# UNITED STATES PATENT AND TRADEMARK OFFICE

APPLICATION NO.	FILING DATE	FIRST NAMED INVENTOR	ATTORNEY DOCKET NO.	CONFIRMATION NO.
10/728,901	12/08/2003	Mitsushi Ikeda	04329.3193	9313

<b>Office Action Summary</b>	<b>Application No.</b> 10/728,901	<b>Applicant(s)</b> IKEDA ET AL.	
	<b>Examiner</b> Christine Sung	<b>Art Unit</b> 2884

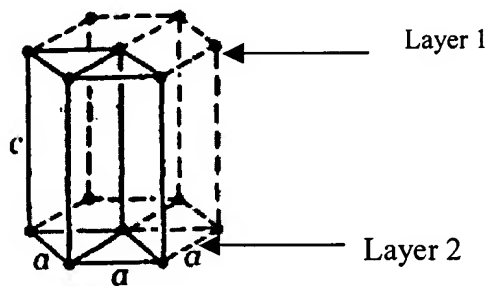
Regarding claim 1, Ikeda disclose a flat panel x-ray detector (figure 2) which comprises:

an X-ray-charge conversion film converting incident X-rays into electric charges (Figure 2, elements 208-211);

and a pair of electrodes (elements 212 and 103) disposed in contact with both surfaces of said X-ray-charge conversion film (see figure 2, where 212 and 103 are disposed on opposite ends of the conversion film);

wherein said X-ray-charge conversion film has a laminate structure (Figure 2, elements 208-211) including a plurality of metal halide films laminated (Claim 1, column 12, line 66- column 13, line 2) and differing in band gap from one another or differing in resistivity (Claim 1, column 12, line 66- column 13, line 2, materials of different resistivity inherently have different bandgaps), and halogen atoms contained in said plurality of metal halide films are of the same kind among them (column 10, lines 1-3). Ikeda discloses that the laminated materials are hexagonal structured elements such as  $\text{PbI}_2$  (column 12, lines 24-26), but does not explicitly state that they are laminated in the direction of the c-axis. However, it is inherent that the layers of a hexagonal structure must be laminated within the c-axis because there are no other planes in which the layering could occur.
